Number I.1
Section Steering

FITTING TOOL FOR STEERING BOX TOP COVER

Number I.7.
Section Steering

INTRODUCTION OF MODIFIED UPPER STEERING COLUMN.

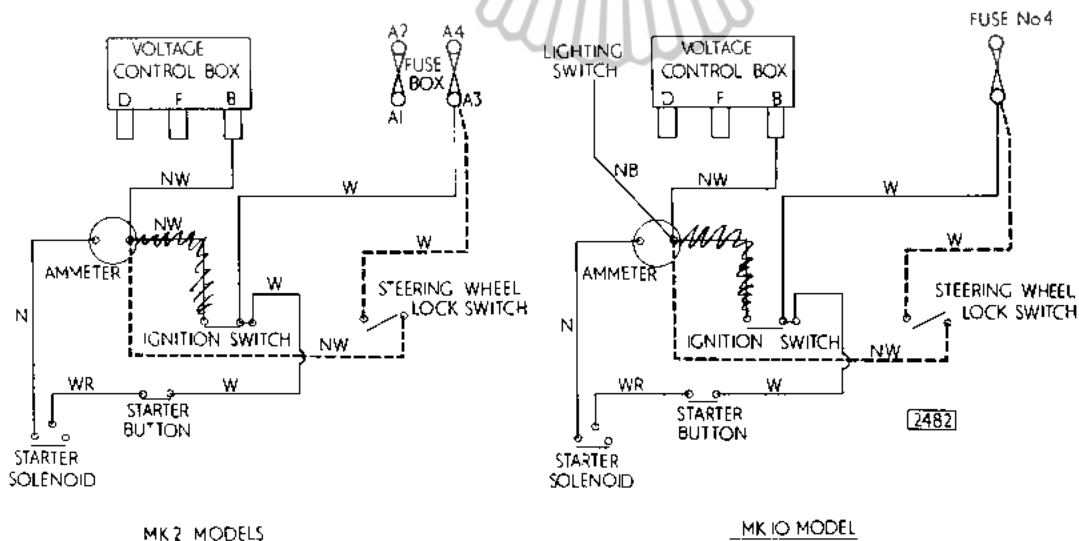
- (2) (a) Pass the long white cable with P.V.C. sleeve through the bulkhead tape to the main harness up to the fuse box and connect to terminal A.3. (Mark 2 only).
- (b) Connect single white cable with Black P.V.C. sleeve to vacant terminal on fuse 6 or 7 (Mark 10).
- (3) Tape the steering lock connector to the harness on the steering column and connect to the lock switch as follows:

Connect the white cable to terminal No. 15.

Connect the brown and white cable to terminal No.30.

Remove the terminal from the switch cable ends and strip the cables $\frac{3}{8}$ " (9.5 mm) before connecting to the switch.

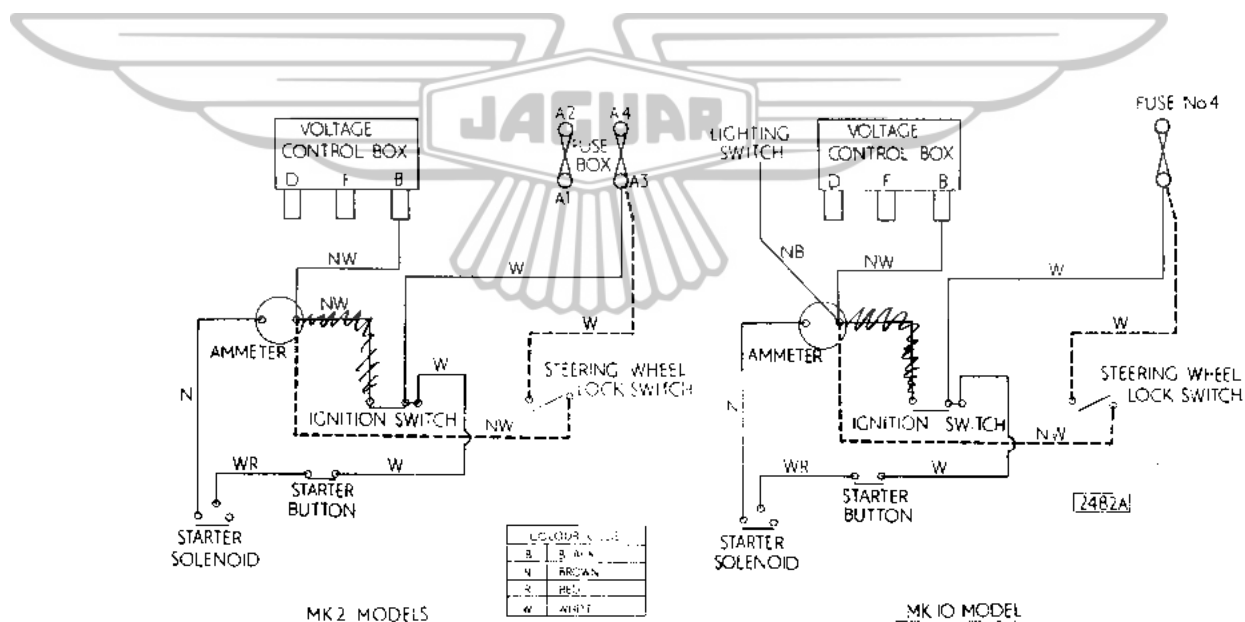
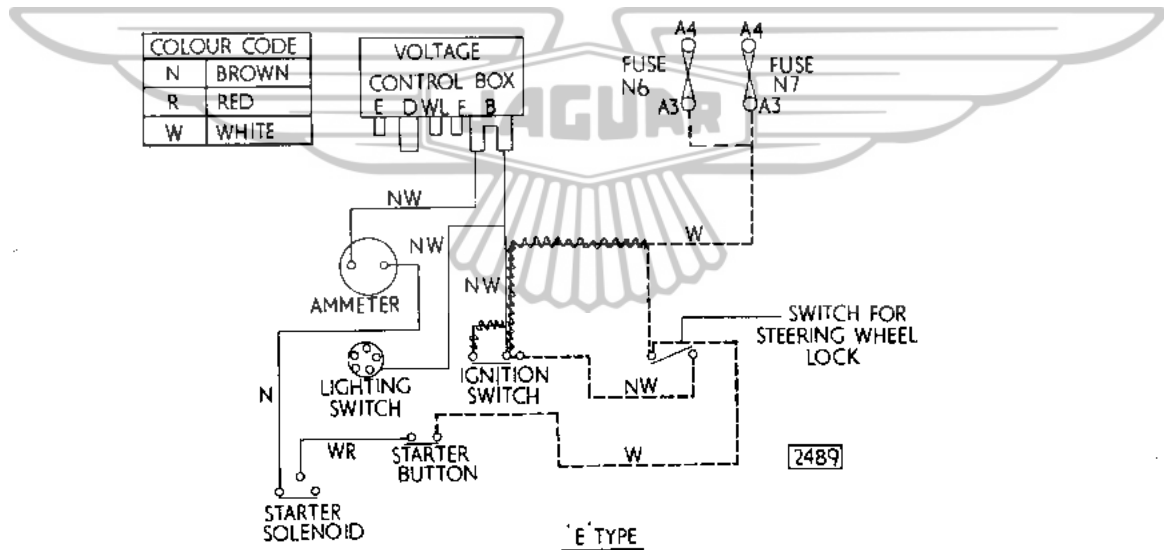
- (1) Connect the single white cable - paired with brown and white cable - to the vacant terminal on the starter switch.
- (2) Connect the adjacent brown and white cable to the vacant blade of double terminal on existing ignition switch and tape the connector harness to the main harness on the instrument panel.
- (3) Connect the single white cable, with black P.V.C. sleeve, to the vacant terminal on fuse 6 or 7.
- (4) Tape the steering lock connector harness to the harness on the steering column and connect the double white cable to the terminal 15, and adjacent brown and white cable to terminal 30 of steering column lock.

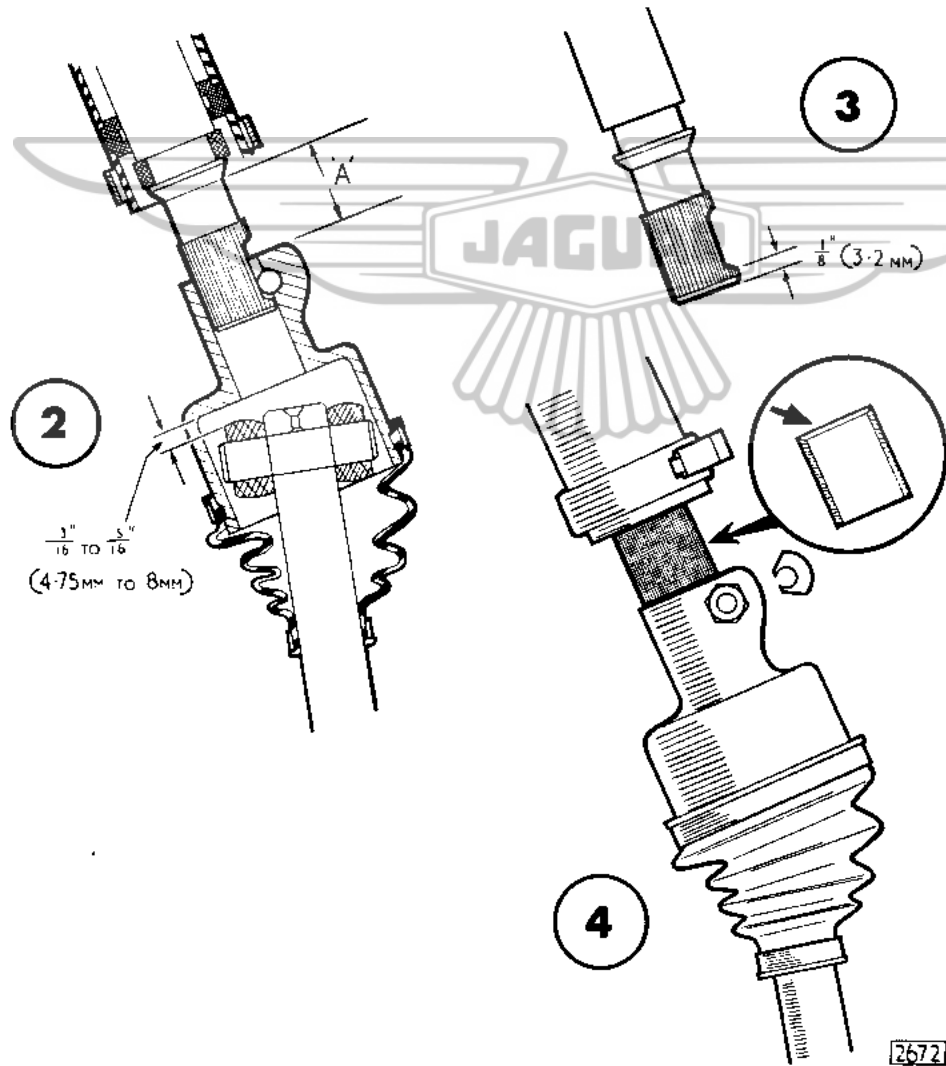
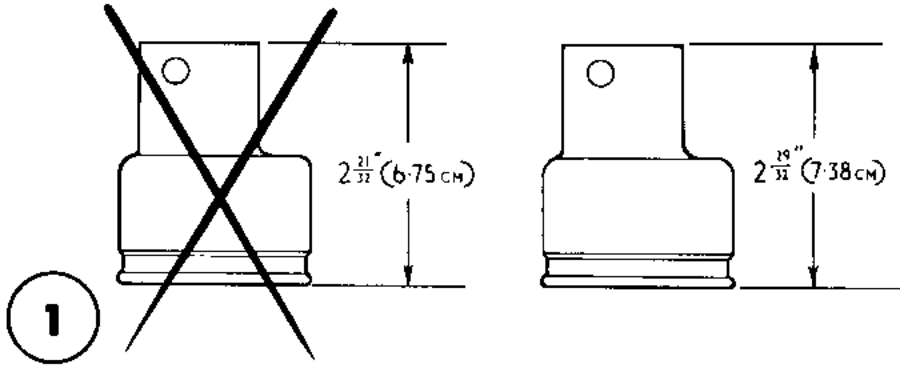
3. Measure the distance from the top machined face to the bottom machined face of the top joint socket on the lower steering column (See Fig.1). If it is less than $2.29/32"$ (7.38 cm) long a new socket (9980) should be fitted. (The socket to be replaced measures $2.21/32"$ (6.75 cm).

4. Press the top joint socket down until it bottoms and then raise towards the upper column until a minimum of $3/16"$ (4.76 mm) or a maximum of $5/16"$ (7.93 mm) movement is achieved. This movement will be controlled by the position of the upper steering outer column which can, if necessary be moved forward to meet the lower steering column by adjustment at the fixing bracket to the dash and loosening the securing clip (C.2905/4) on the scuttle.

Having achieved the condition described in the previous paragraph now measure the distance between the top machined face of the top joint socket and the bottom of the chamfer on the inner column ("A" Fig.2) to ascertain if the spacing collar (C.22698) which is $1.3/32"$ (2.78 cm) long can be fitted. If necessary the spacing collar can be reduced in length by cutting at the unchamfered end.

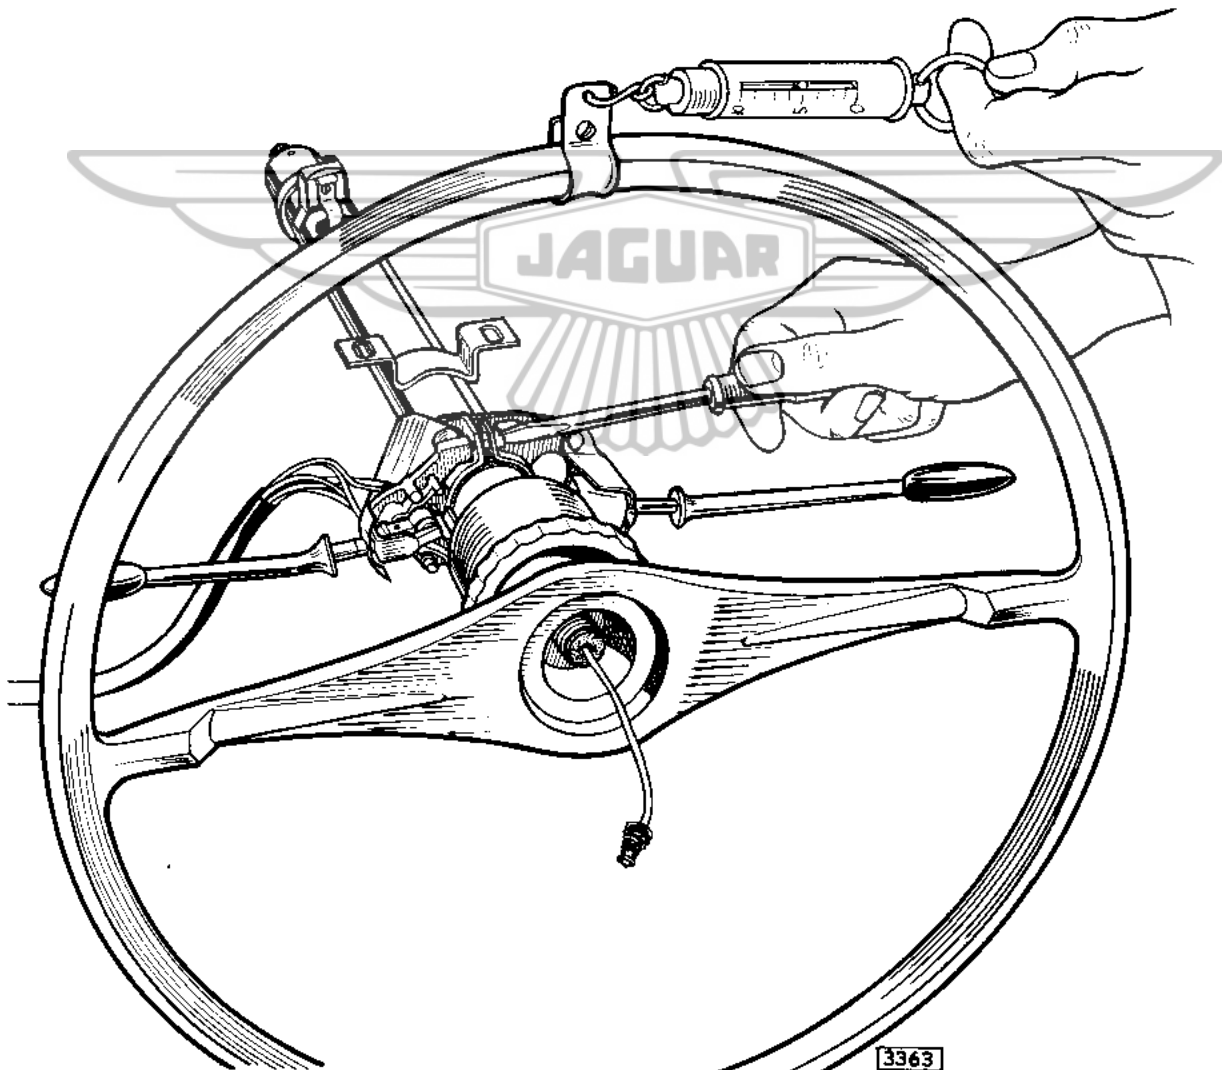
Tighten the top screw until the wheel will just turn with a pull of 5ozs (141.7 grammes) registered on the balance (see illustration).

Two thicknesses of distance piece are available to compensate for any variations in the bore of the column.

Grade 'A'	.188" (4.7 mm)	(Part number C.26023/1)
Grade 'B'	.106" (4.06 mm)	(Part number C.26023/2)

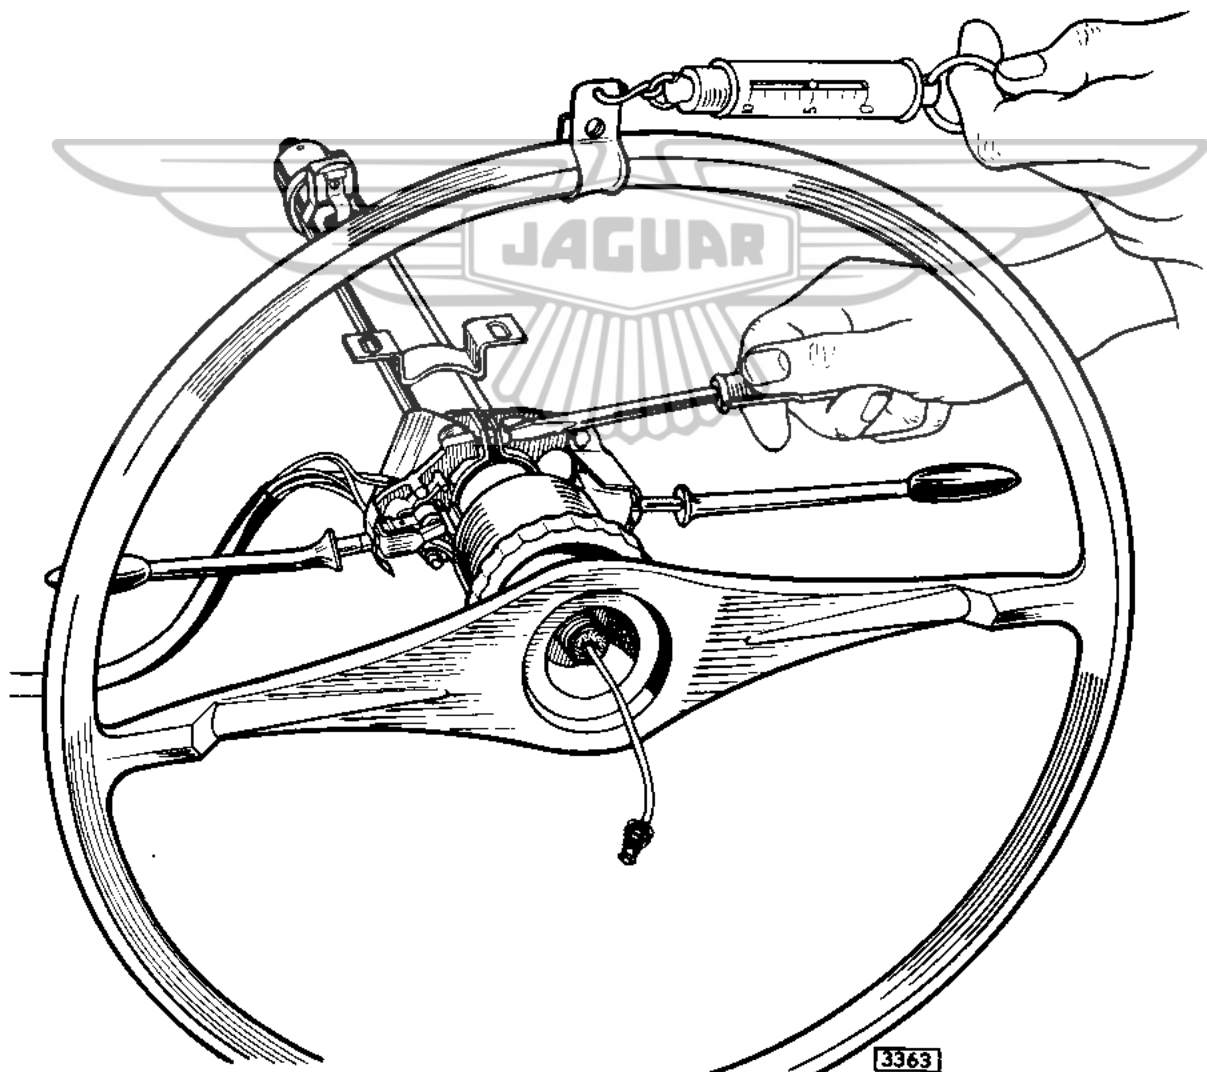
Tighten the top screw until the wheel will just turn with a pull of 5 ozs (141.7 grammes) registered on the balance (see illustration).

Two thicknesses of distance piece are available to compensate for any variations on the bore of the column.

Grade 'A' .188" (4.7 mm) (Part Number C.26023/1)

Grade 'B' .160" (4.06 mm) (Part Number C.26023/2)
